S600-S474

TECHNICAL BULLETIN

**Part-Load Engine Breather – Partial Blockage
of Restrictor – Scheduled Cleaning –
Service Action S474**

MODEL 2000-01 MY
S-TYPE
VIN L00001-L93444

ILLUSTRATION 1

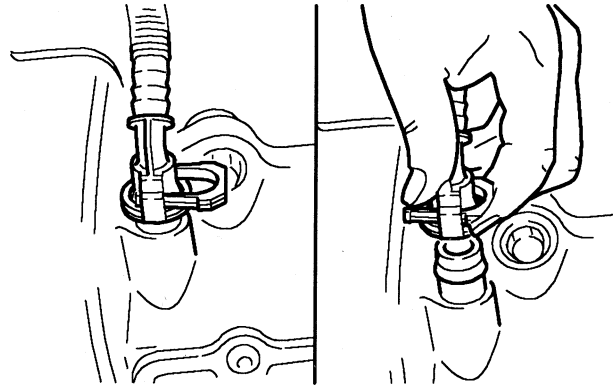
4. Depress the retaining clip (Illustration 1) of the connector of the part-load breather line, allowing the line connector to be disconnected from the breather stub on the left camshaft cover.
5. Insert a $3/32$ " (2.5 mm) diameter drill bit in a hand-held pin chuck such as Snap-on Tools® Part No. YA 806 (Illustration 2). **Verify that the drill bit does not exceed $3/32$ " (2.5 mm) diameter.**

ILLUSTRATION 2

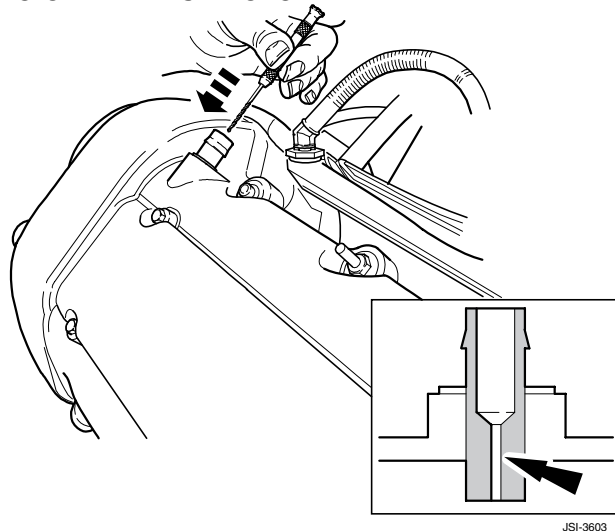
⚠ Caution: Do not use a power drill under any circumstances. The drill bit must always be turned by hand only. Using a power drill can damage the restrictor or the breather stub which needs to provide a good seal to the connector of the flexible breather line.

⚠ Caution: Do not allow the diameter of the restrictor to increase. Use a micrometer to verify that the diameter of the drill bit does not exceed 0.098 inch (2.5 mm.).

- Carefully push the drill tip into the breather stub and through the restricter while slowly rotating the drill to clear any deposits that may have accumulated inside the restricter. The top end of the restricter is approximately 30 mm below the tip of the line stub and extends for an additional 5 mm into the camshaft cover.

As a result, the tip of the drill bit must penetrate into the stub at least 40 mm to ensure penetration through the entire length of the restricter. No damage will occur if the tip of the drill bit penetrates 45 mm.
